Recall Repair Instructions

NHTSA Recall # 25V-554

Tiffin Motorhomes Recall # TIF-146

Purpose: To replace the incorrect buckle portion of the rear passenger's and driver's side seatbelt with the correct length.

Figure 1A

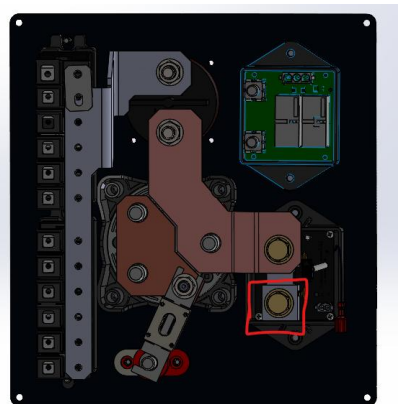
1. Turn off the main red and black power switches, shown in figure 1A.
2. Loosen screws on the side and the top rear of the wood DCD board frame to allow access to the passenger's side seatbelt, see figure 1A. Use caution, the battery connection show in figure 1B will still be active.
